## Product Advisory

Issue Date: Aug 26, 2021

Supply chain continuity: Adding Foxconn Nanning in China as a contract manufacturing site for Ethernet NIC to maintain supply chain continuity.

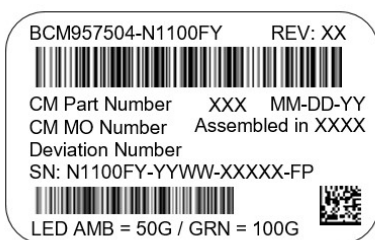
The CM location is traceable through the board serial number. The letters “FN” at the suffix of the serial number indicate Foxconn, Nanning in China manufactured the board. Below is an illustrative example. OEMs may have a different CM site code.
